NEW FEATURES

SEAT

■ FRONT SEAT

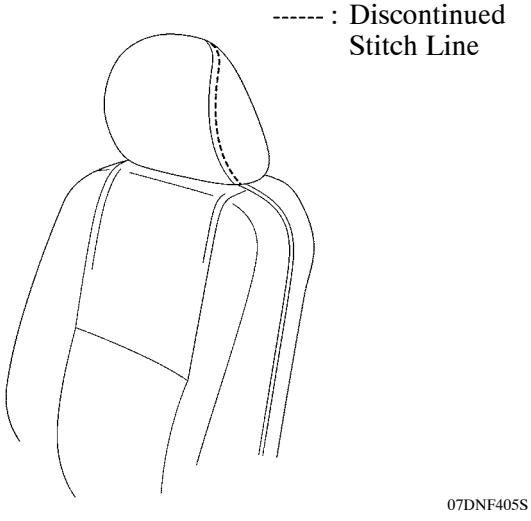
The forward tilt angle of the front passenger seat has been increased from 14° to 40° to improve the ease of getting in and out of the rear passenger seat.

■ HEADREST

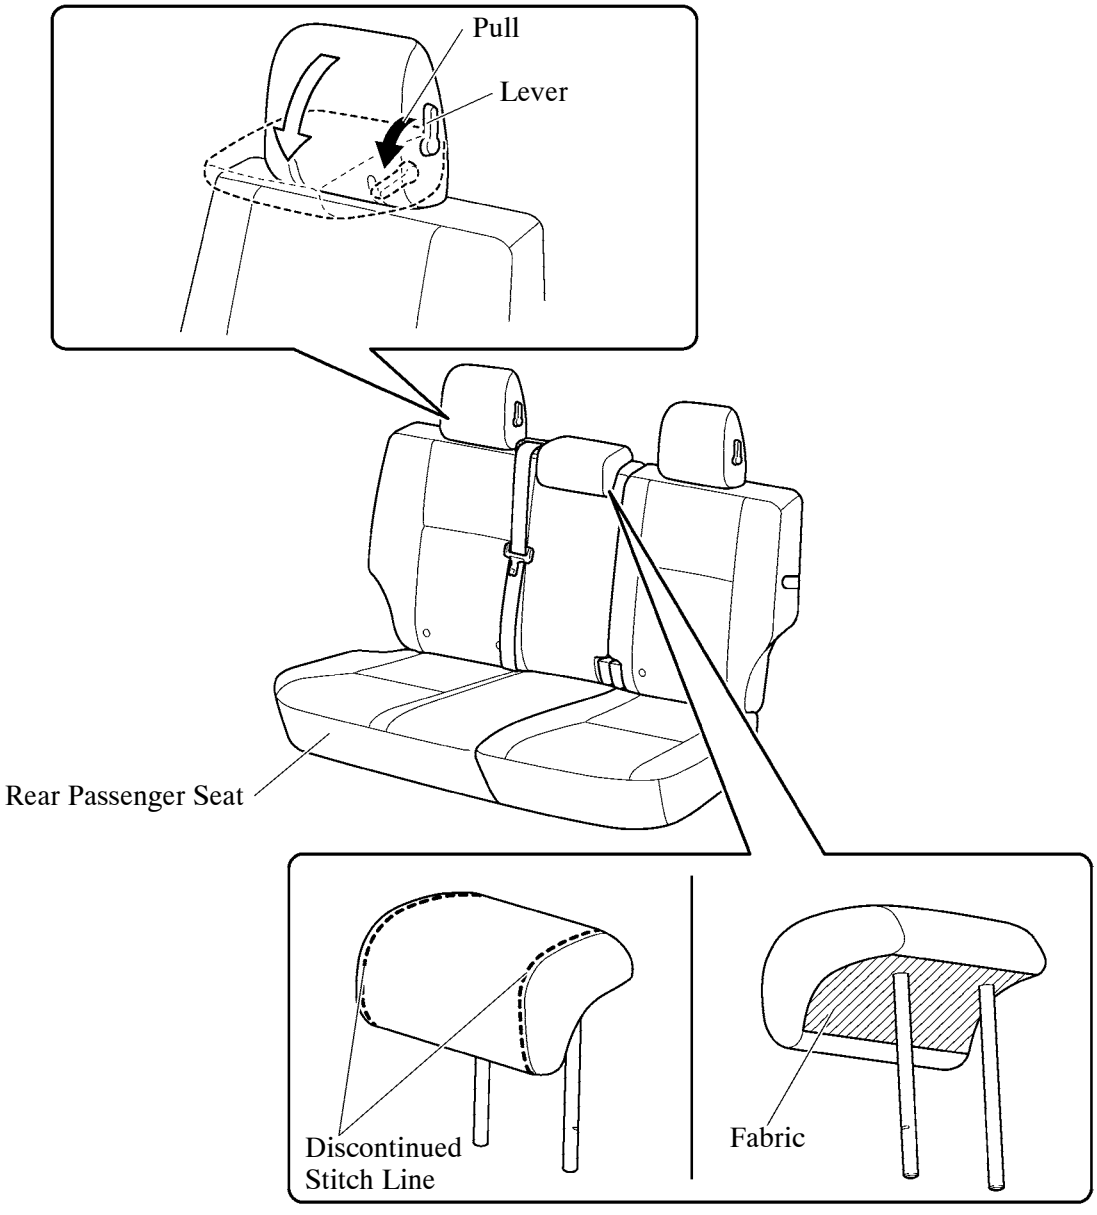
- The decorative stitch lines on the front and rear headrests have been discontinued.
- The bottom surface of the center rear passenger seat cover has been changed from soft leather to fabric.
- The side rear passenger seat headrests have been increased in size, and a fold-down mechanism is used to ensure occupant protection and rearward visibility. The headrest can be folded forward by operating the lever on the side of the headrest.
